## **Addendum No. 1**

To:  
New Community Building  
Trumann Housing Authority  
Trumann, AR  
April 16, 2024

The Plan holder's attention is hereby directed to the following changes in the drawings and specifications.

SHEET NUMBER:  
**AD-01.1**

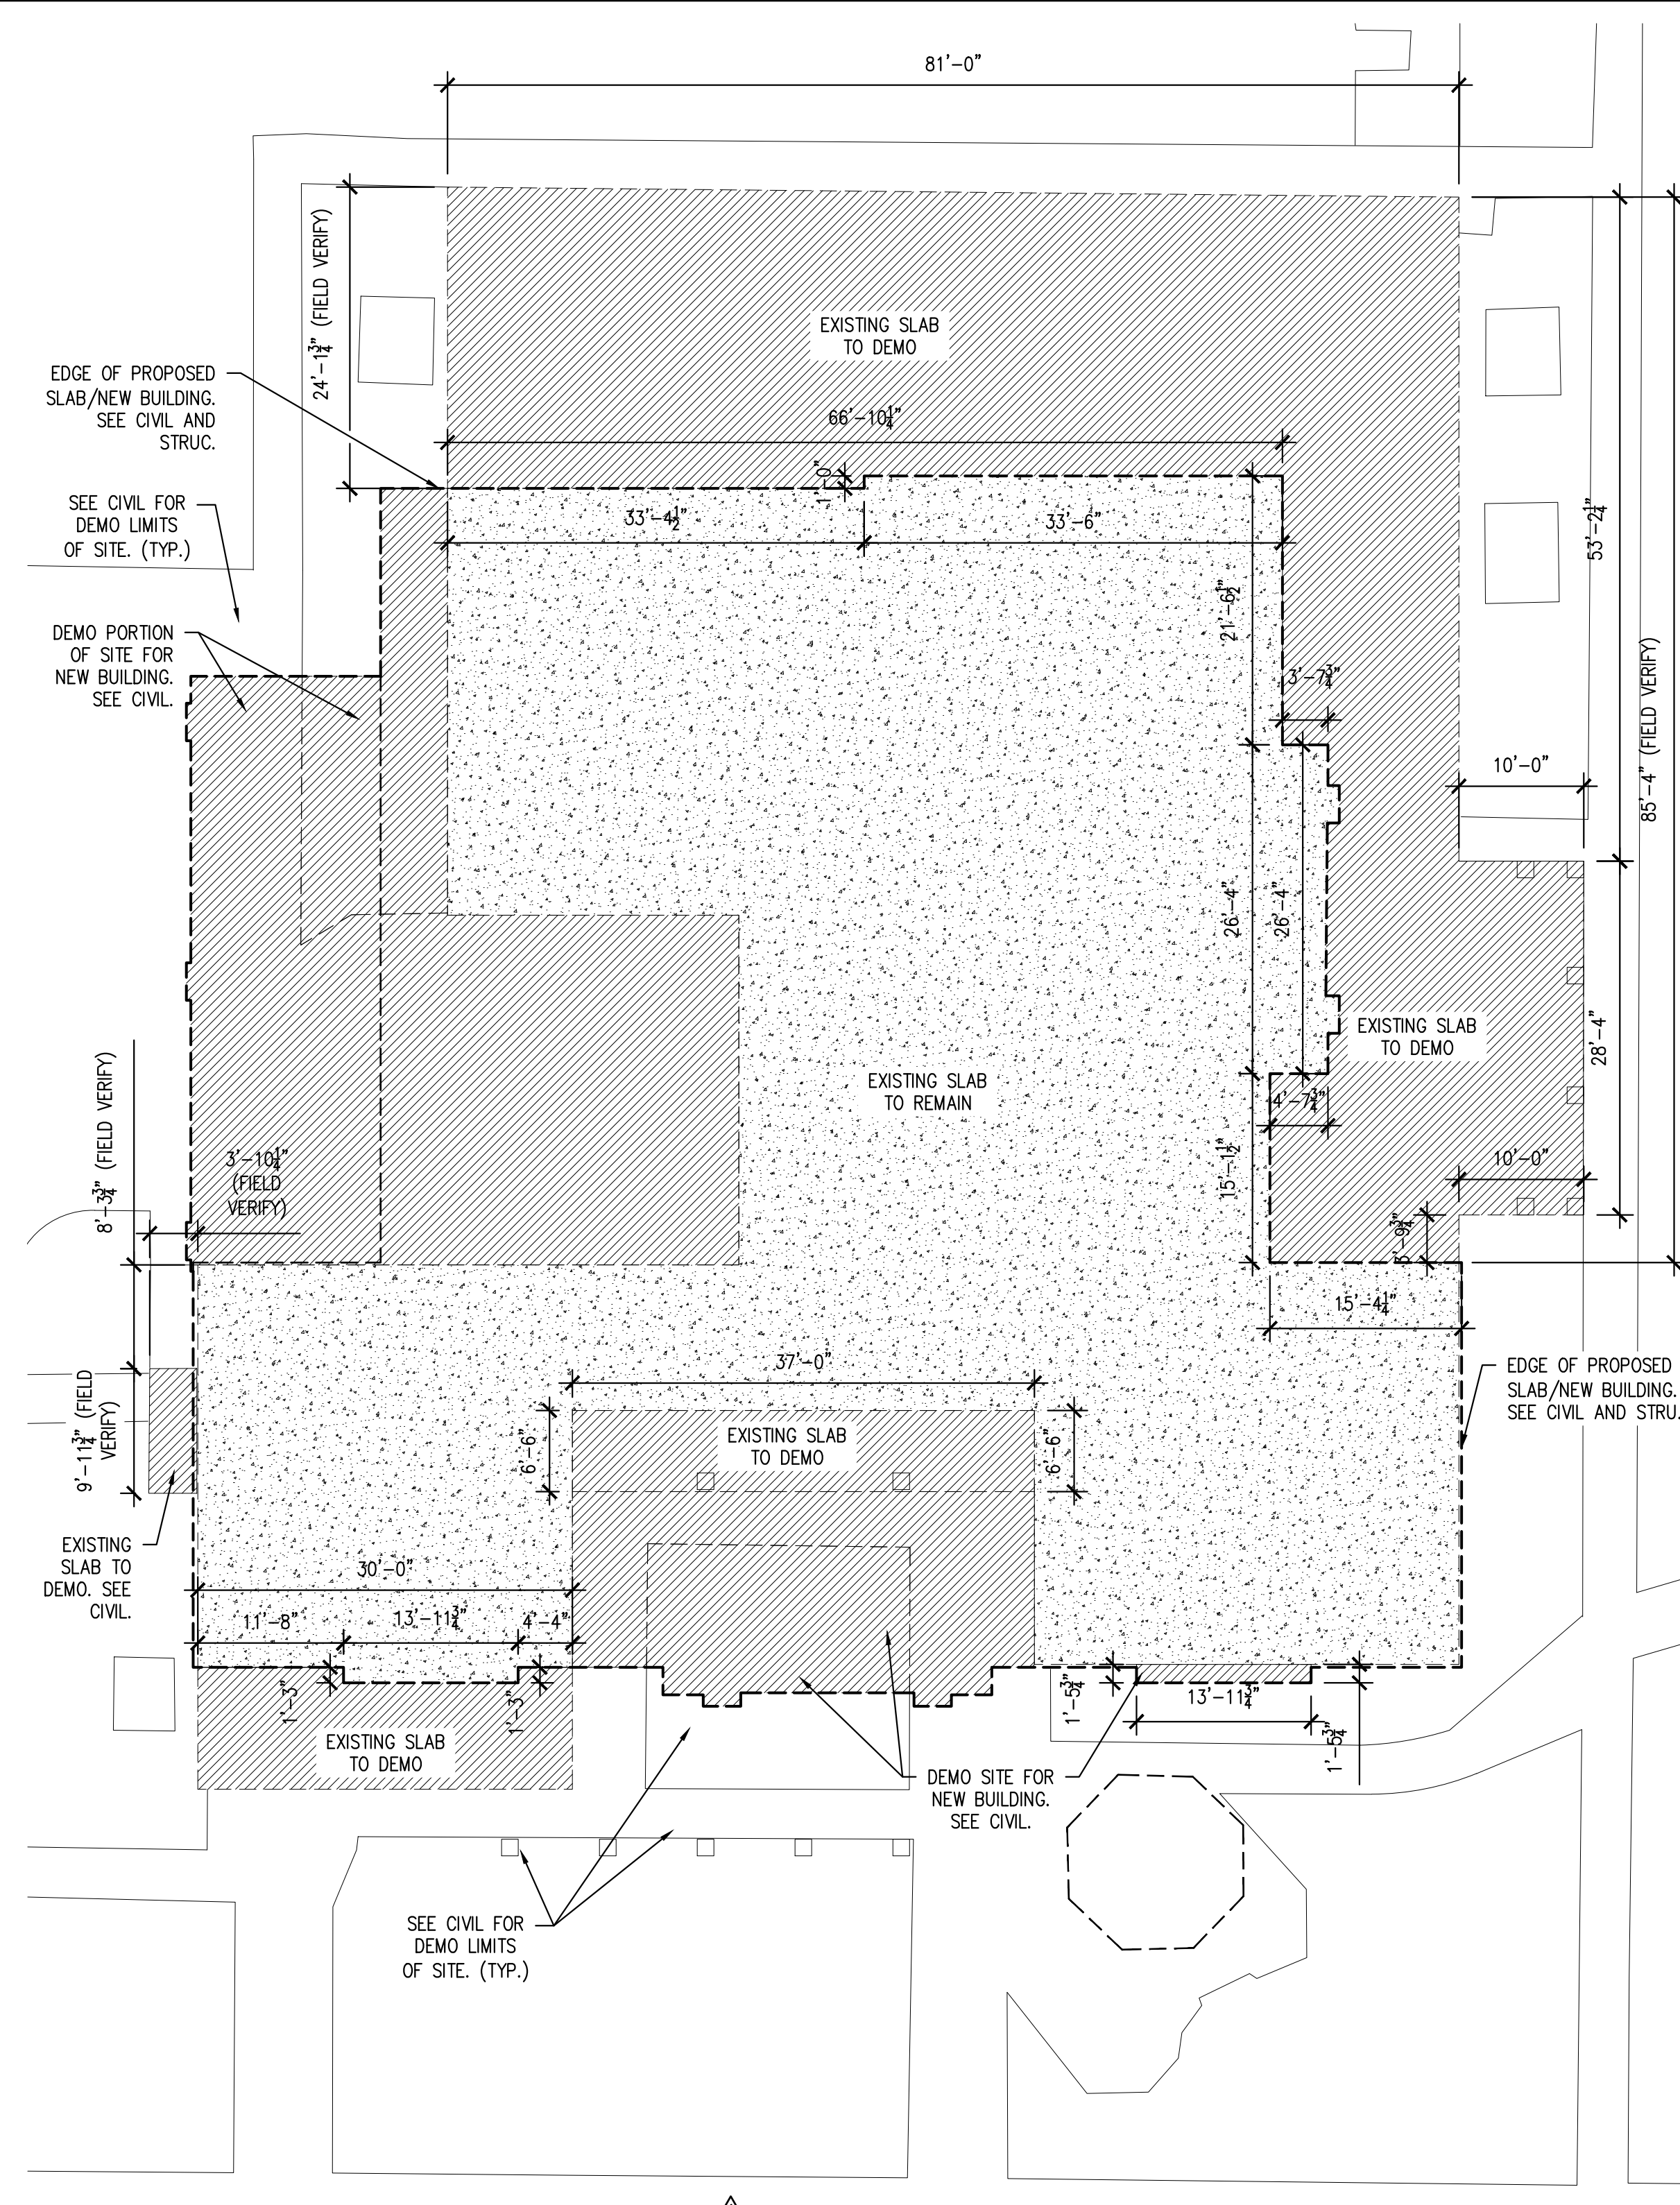
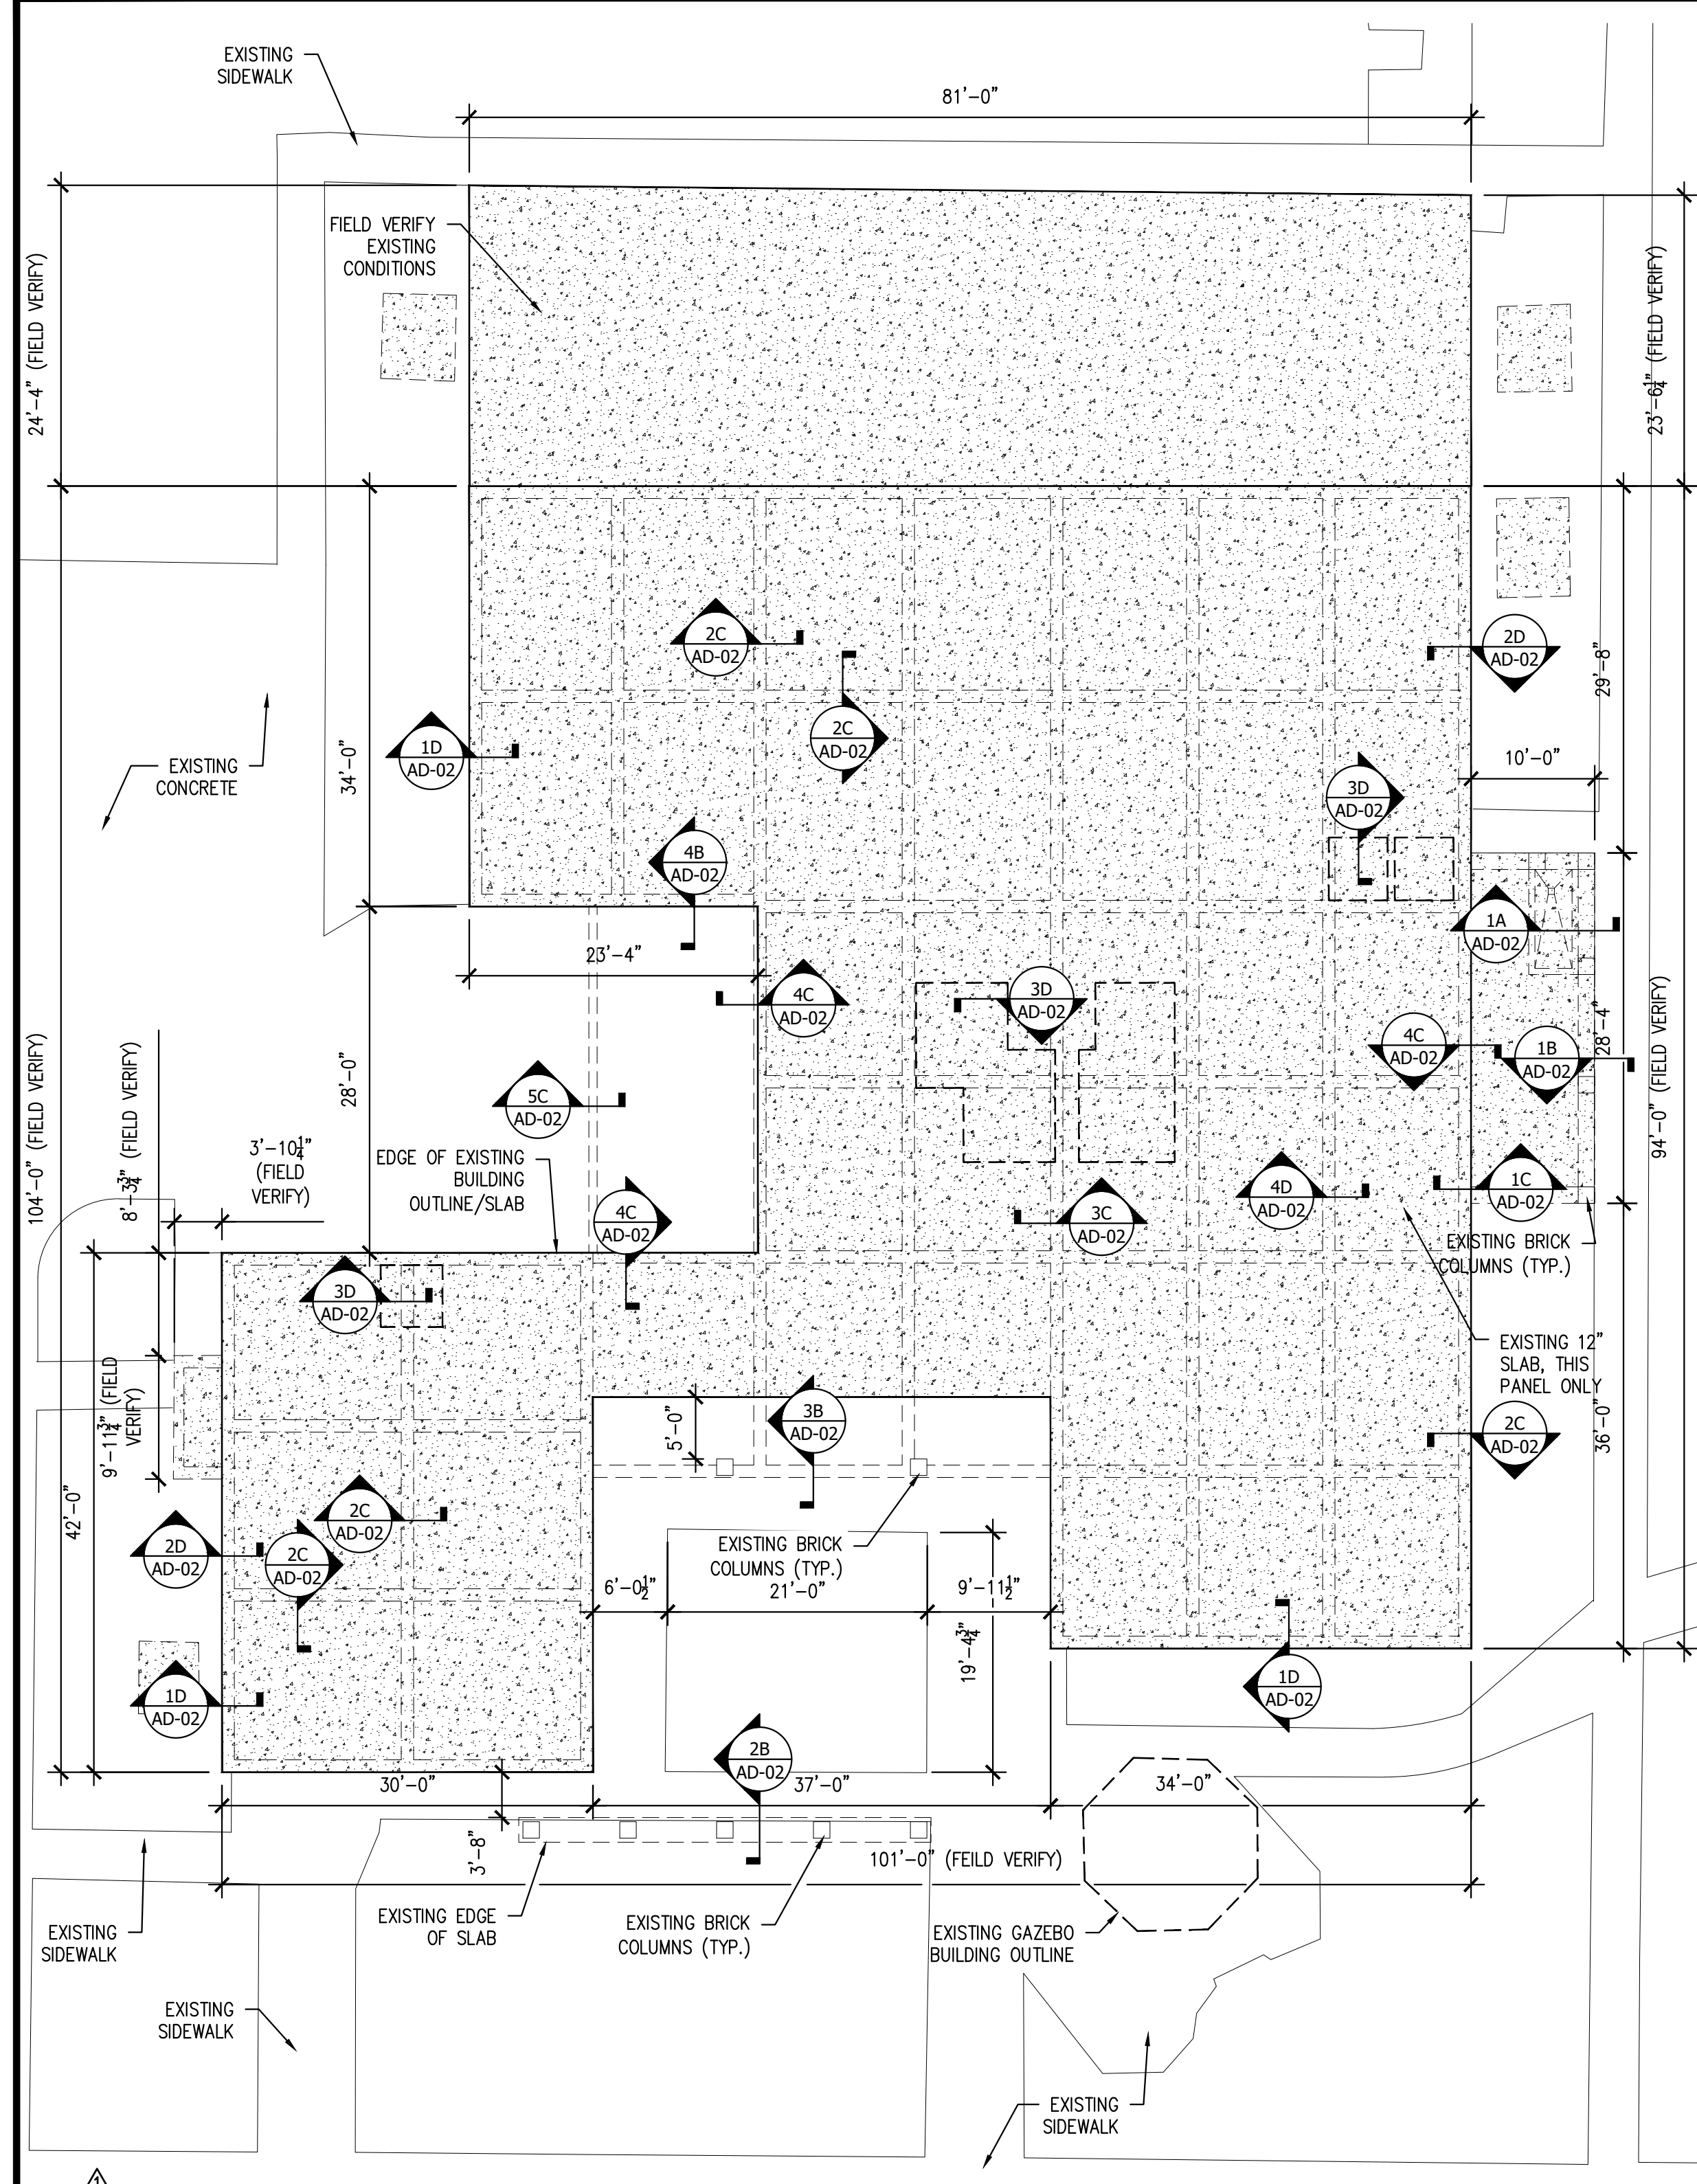
- Item No. 5:** **Revised Drawing:** Existing slab to be demoed is notated with contrasting hatching (Updated sheet AD-01 and New sheet AD-01.1 attached)

1A REFLECTED CEILING PLAN  
 SCALE: 3/16" = 1'-0"

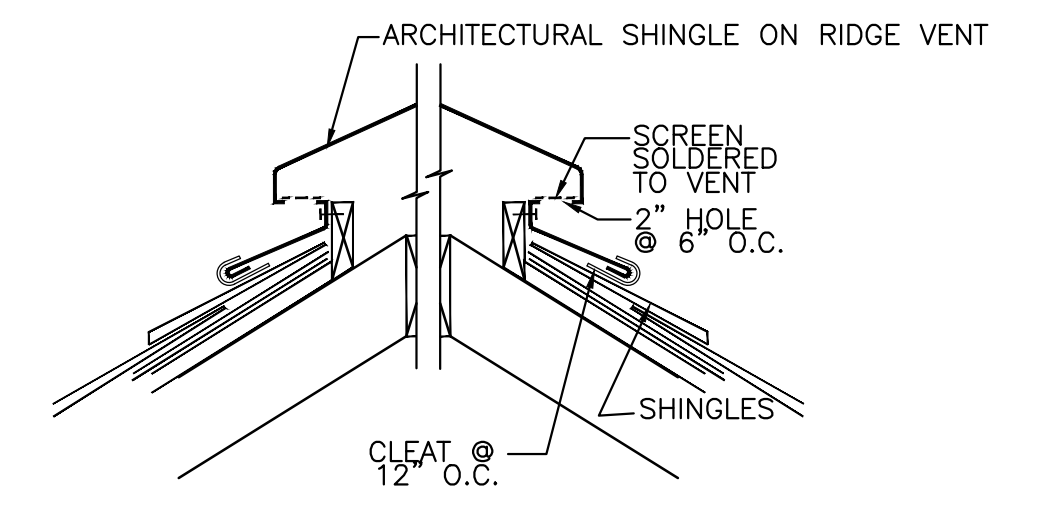
- Item No. 4:** **Revised Drawing** The truss height of porch ceilings has been added to sheet A-02. Note height of brick masonry arch may lower for coordination after Architect's notice and approval.
